CITY COUNCIL AGENDA

January 5, 2011

59. SDR-40146 - SITE DEVELOPMENT PLAN REVIEW - PUBLIC HEARING - APPLICANT: THE SMITH CENTER - OWNER: CITY OF LAS VEGAS - Request for a Major Amendment to a previously approved Site Development Plan Review (SDR-26709) FOR A PROPOSED FIVE-LEVEL, 335-SPACE PARKING GARAGE WITH WAIVERS OF THE SYMPHONY PARK PARKING STRUCTURE DESIGN STANDARDS, BUILD-TO LINE STANDARD, REQUIRED RETAIL FRONTAGE STANDARD AND STREETSCAPE STANDARDS on a portion of 5.10 acres at the northeast corner of Clark Avenue and Promenade Place (APN 139-33-610-026), PD (Planned Development) Zone, Ward 5 (Barlow). Staff recommends DENIAL. The Planning Commission (6-0 vote) recommends APPROVAL.

SHEET NO.
L8.02

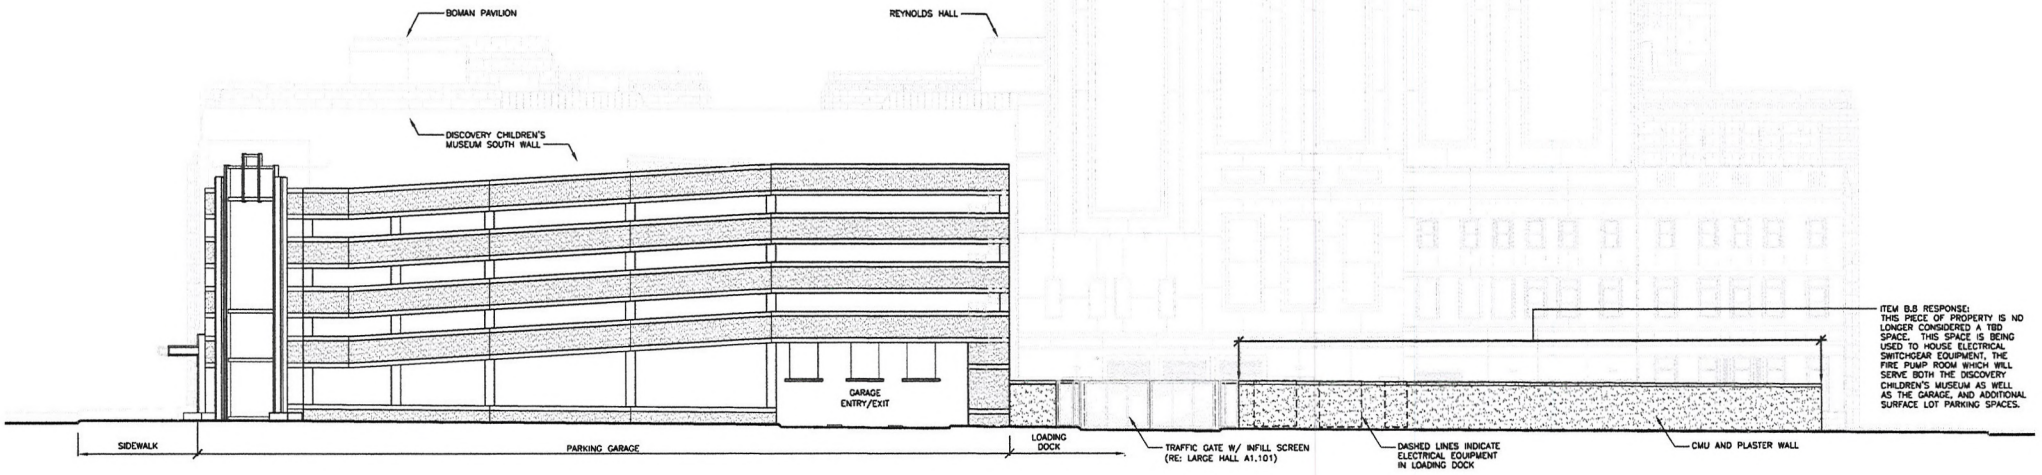
8. Sheet L8.01 – Two additional details are needed – one for a continuous tree trench and one for a metal support system for the Italian Cypress.
9. Sheet L8.02 – Detail B needs to be modified to indicate 22 feet as the BTH on the Palm instead of "Height Varies".

SHEET NO.
GA2.01

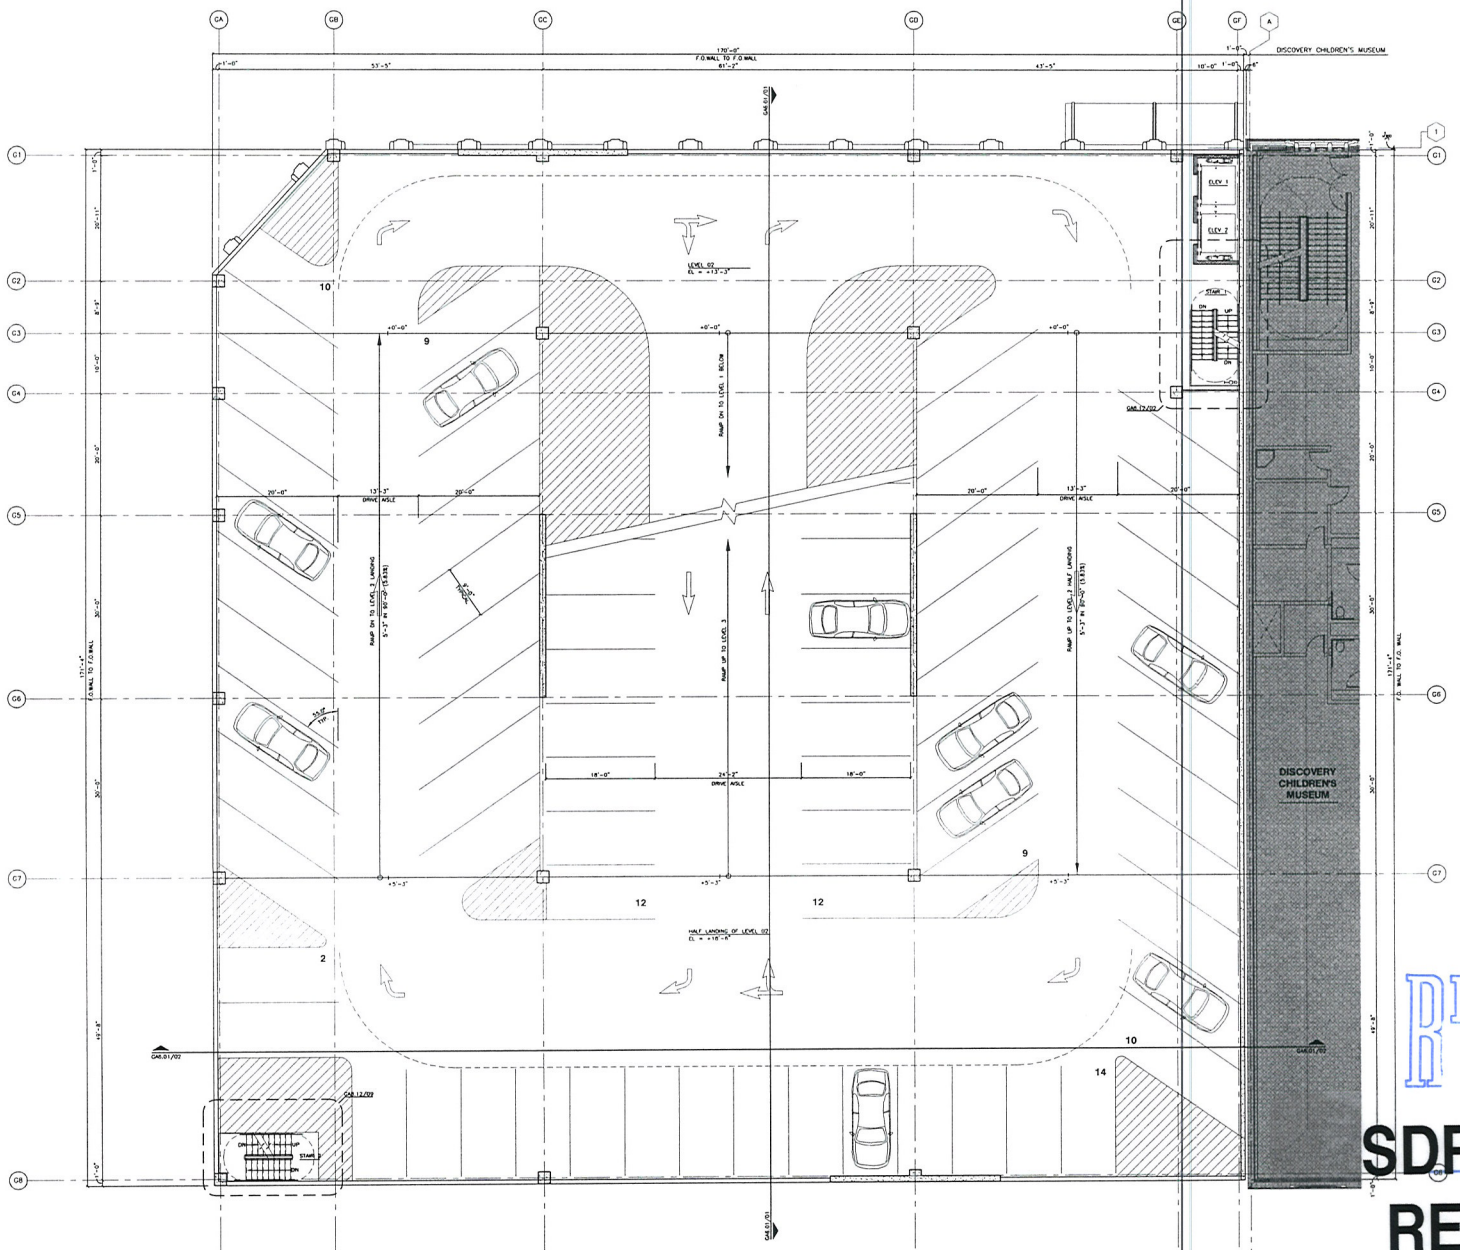
1. Sheet GA2.01- the circulation of the ground level shown in the revised garage is confusing and creates conflict points for patrons. Please modify. Also the planters shown on the Promenade Place sidewalk extend too far into the sidewalk and reduce the pedestrian space well below the 10 foot minimum required. Please reduce the size of the planters to the build-to-line.

SHEET NO
GA5.01

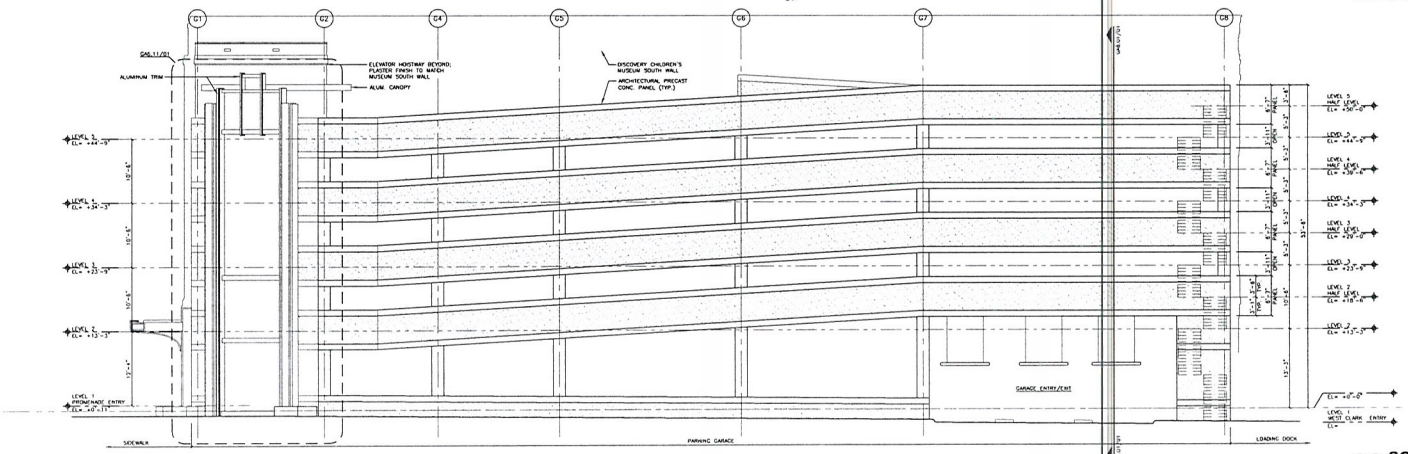
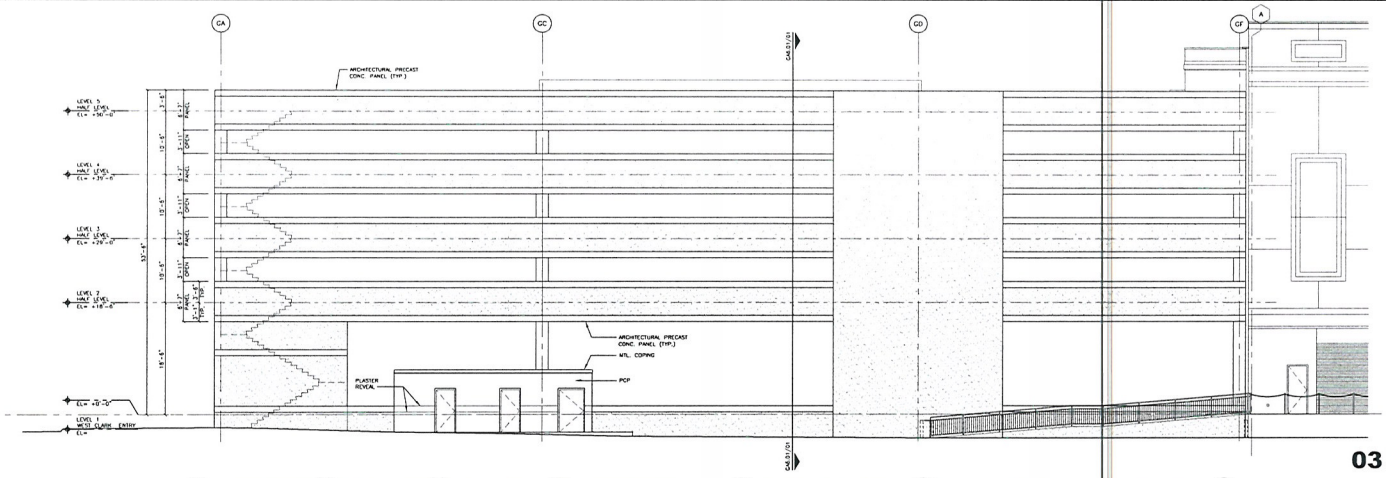
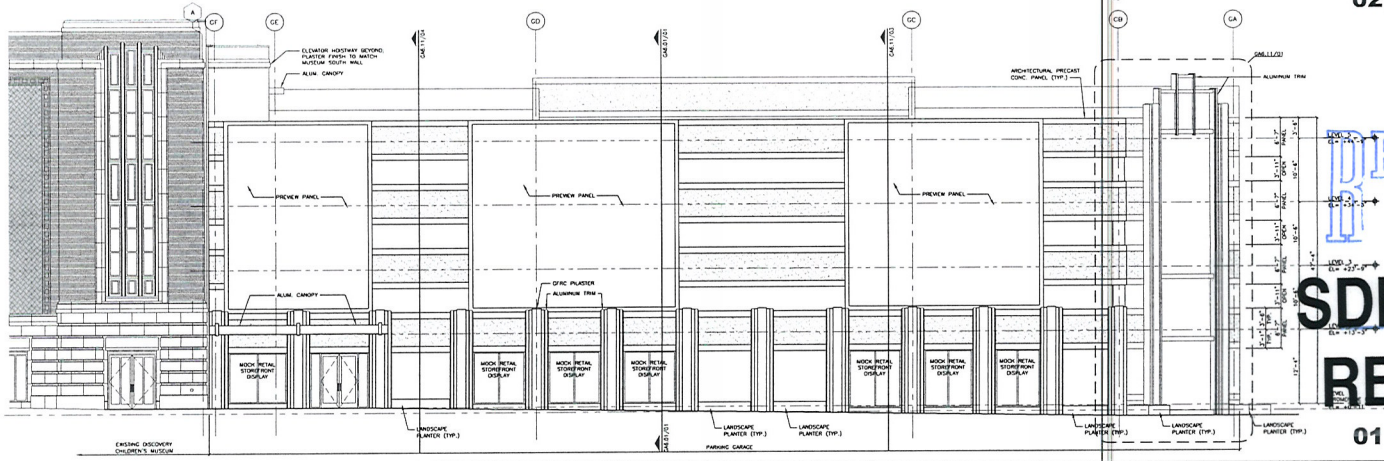
1. The Garage elevations shown on Sheet GA5.01do not reflect any of the last set of comments from the SP-DRC and are found to be lacking the quality of architecture required for them to be approved per the Design Standards. If approved anyway, the following Sections of the Required Design Standards would have to be waived, presented here with a parenthetical note of how the current project responds.

2. Sheet GA5.01
   a. Provide canopies along the rest of the Promenade Place elevation over the display openings.
   b. Provide an architectural treatment on the West Clark Avenue elevation similar to the Promenade Place elevation
